# Access Compliance Report

## Public Rights-of-Way

### (Island Curb Cuts)

Intersection ID: 10032380	Main Street: MT_HOLLY-HUNTERSVILLE_RD	Cross Street: N/A	Location: NW
ADA ID: 7671A1AE3CC4	Curb Cut Type: MedianRefuge2	Initial Pass/Fail: Fail	Overall Compliance: No
Codes/Mitigation Info/Possible Solution		Field Measurements/Component Compliance	
Severity Score: 25

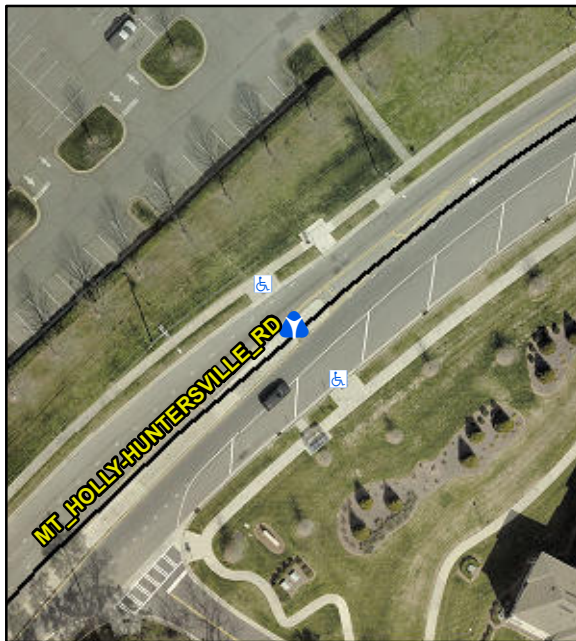
Compliance	Description	Data	Compliance	Description	Data
Yes	Refuge 1 Length (In)	62.0	N/A	Gutter 1 Ponding?	N/A
Yes	Refuge 1 Width (In)	71.0	N/A	Gutter 1 Lip Ht (In)	N/A
No	Refuge 1 Slope (%)	9.2	N/A	Gutter 1 Slope (%)	N/A
Yes	Refuge 1 X Slope (%)	1.4	N/A	Gutter 1 X Slope (%)	N/A
N/A	Painted X Walk1?	No	N/A	DWS 1 Provided?	N/A
N/A	X Walk 1 Direction	To NW	N/A	DWS 1 Contrast?	N/A
N/A	X Walk 1 Width (In)	N/A	N/A	DWS 1 Length (In)	N/A
N/A	Road 1 Slope (%)	2.2	N/A	DWS 1 Full Width?	N/A
N/A	Road 1 X Slope (%)	4.2	N/A	DWS 1 Offset (In)	N/A
Yes	Refuge 2 Length (In)	62.0	N/A	Gutter 2 Ponding?	N/A
Yes	Refuge 2 Width (In)	71.0	N/A	Gutter 2 Lip Ht (In)	N/A
No	Refuge 2 Slope (%)	9.2	N/A	Gutter 2 Slope (%)	N/A
Yes	Refuge 2 X Slope (%)	1.3	N/A	Gutter 2 X Slope (%)	N/A
N/A	Painted X Walk2?	No	N/A	DWS 2 Provided?	N/A
N/A	X Walk 2 Direction	To SE	N/A	DWS 2 Contrast?	N/A
N/A	X Walk 2 Width (In)	N/A	N/A	DWS 2 Length (In)	N/A

**Remove & Replace Entire Refuge.**
